Access Compliance Report

Public Rights-of-Way

(Curb Ramps)

Intersection ID: 14382	Main Street: BROOKHILL_RD	Cross Street: REMUS_RD	Location: W
ADA ID: 8B9AC979FB02	Ramp Type: PerpDiag	Initial Pass/Fail: Fail	Overall Compliance: No
Codes/Mitigation Info/Possible Solution		Field Measurements/Component Compliance	
Severity Score: 33.75

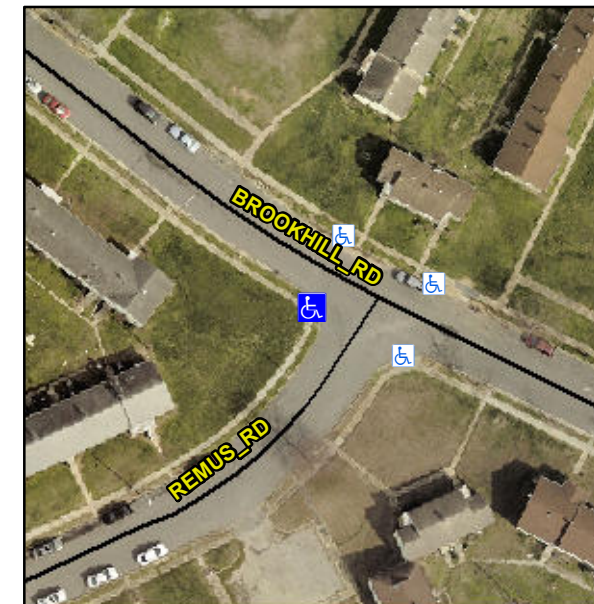
Not Found, R304.5.1, R304.2.2, R304.5.3

Compliance	Description	Data	Compliance	Description	Data
N/A	Ramp Length (in)	89.0	No	Ramp Slope (%)	11.6
No	Ramp Width (in)	41.0	No	Ramp XSlope (%)	6.9
N/A	Flare Type LT	N/A	N/A	Flare Type RT	N/A
N/A	Flare Slope LT (%)	N/A	N/A	Flare Slope RT (%)	N/A
N/A	Flare Traversable LT?	N/A	N/A	Flare Traversable RT?	N/A
N/A	Landing Length (in)	N/A	N/A	DWS Provided?	N/A
N/A	Landing Width (in)	N/A	N/A	DWS Contrast?	N/A
N/A	Landing Slope (%)	N/A	N/A	DWS Length (in)	N/A
N/A	Landing X Slope (%)	N/A	N/A	DWS Full Width?	N/A
N/A	Landing Curb? (Y/N)	N/A	N/A	DWS Offset (in)	N/A
N/A	Shared Landing?	N/A			
N/A	Gutter Ponding?	N/A	N/A	Gutter Slope (%)	N/A
N/A	Gutter Lip Ht (in)	N/A	N/A	Gutter X Slope (%)	N/A
N/A	Painted X Walk1?	No	N/A	Painted X Walk2?	No
	X Walk 1 Direction	To SE		X Walk 2 Direction	To NE
N/A	X Walk 1 Width (in)	N/A	N/A	X Walk 2 Width (in)	N/A
	X Walk 1 Slope (%)	4.1		X Walk 2 Slope (%)	9.3
	X Walk 1 X Slope (%)	7.2		X Walk 2 X Slope (%)	0.8

Remove & Replace Curb Ramp With Two New Directional Ramps or Equivalent.
